SERVICE BULLETIN

DATE: 20 July 2001

ISSUE: 124

SUBJECT: 429 Carrousel Drive Motor

**Merkle-Korff Paddel Bronze or
Gold in Color**

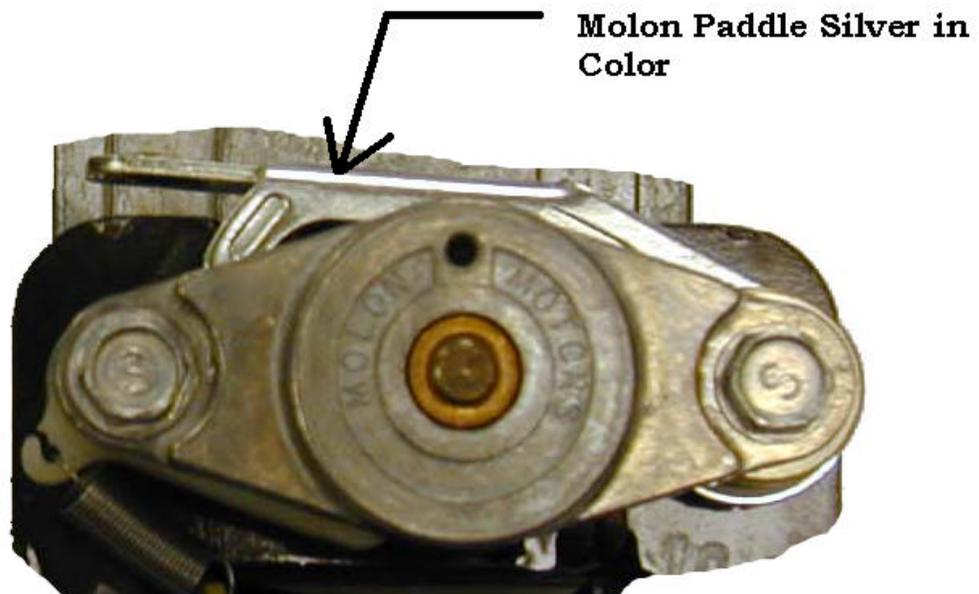
The vendor for the carrousel drive motor has been changed from Molon to Merkle-Korff. These motors are interchangeable and the part number will not change. This change is an effort to improve the reliability of this part.

The easiest way to identify which motor you are working with is to look at the metal brake release paddle (flat metal part that is attracted to motor when it is energized). The metal paddle on the Molon was SILVER in color and the paddle on the new MERKLE-KORFF is BRONZE.
